ITEM 2 - KINGSWOOD ESTATES SUBDIVISION 2022

KPB File No.	2022-183
Plat Committee Meeting:	January 23, 2023
Applicant / Owner:	Melinda and William Nelson of Kenai, Alaska
Surveyor:	Gary Nelson / Ability Surveys
General Location:	Equestrian Avenue, Driftnetter Street, Buoy Avenue, and Seattle Slew Street,
	Kalifornsky

STAFF REPORT

KPB File 2022-183 T 05N R 11W SEC 30 Kalifornsky

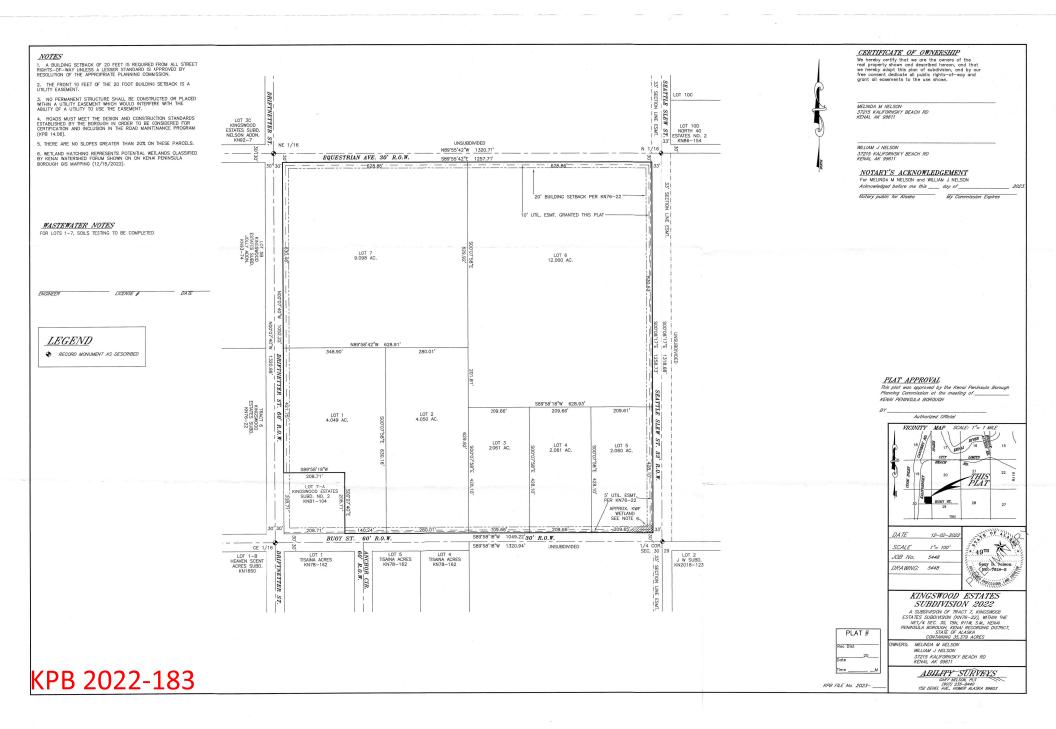
A section line easement is present along the eastern boundary. A parent plat dedicated a 33 foot right-of-way atop the easement. The plat does depict the section line easement continuing to the north and south as those dedications have not occurred at this time. A 33 foot section line easement is being shown adjacent within an unsubdivided property. There is some question on the status of that easement and if the width being shown is correct. **Staff recommends** the surveyor verify the width of the easement with the State of Alaska.

<u>Site Investigation:</u> There are some low wet areas present within the southeast corner. The area is depicted and labeled to reference plat note 6. **Staff recommends** the wetlands remain depicted on the final plat and a wetland determination note be added.

<u>Utility Easements</u> Kingswood Estates Subdivision, Plat KN 76-22, granted a 5 foot clearing easement along the southern and eastern boundary of Tract 7. This easement is being shown to be carried over. **Staff recommends** the label be updated to state "5' <u>clearing</u> esmt..."

Remove the depiction of the setback and 5 foot utility easement within Lot 7-A as it is not part of this subdivision.

Staff recommendation: Include within the description "excepting therefrom, Lot 7A Kingswood Estates Subdivision No. 2. KN 81-104."

- C. The location, width, and name of existing or platted streets and public ways, railroad rights-of-way, and other important features such as section lines or political subdivisions or municipal corporation boundaries abutting the subdivision;
 - **Staff recommendation:** Correct Buoy Street to Buoy Avenue.
- G. The status of adjacent lands within 100 feet of the proposed subdivision boundary or the land status across from any dedicated rights-of-way that adjoin the propose subdivision boundary, including names of subdivisions, lot lines, block numbers, lot numbers, rights-of-way; or an indication that the adjacent land is not subdivided:
 - **Staff recommendation:** Adjust the label or add an additional label for the lots to the northeast as Lot 10C is the same plat as Lot 10D. Update the recording number for the lot to the southeast to 2018-102.

Platting Staff Comments: Soils reports will be required for lots less than 200,000 square feet. Lot 6 and Lot 7 are not required to have a report but may if owners wish to include. Provide appropriate plat notes with lot designations the note applies.

Staff recommendation: comply with 20.60.110. Provide recorded distances and source.

- Subject to an easement issued to Homer Electric Association, Inc. as recorded in Book 6 Page 175, KRD. No definite location disclosed.
 - Any person developing the property is responsible for obtaining all required local, state, and federal permits, including a U.S. Army Corps of Engineers wetland determination if applicable.

Plat note 4 may be removed as no new roads are being dedicated but may remain if desired. Plat note 5 may be removed. Correct plat note 6 as the word "on" is duplicated.
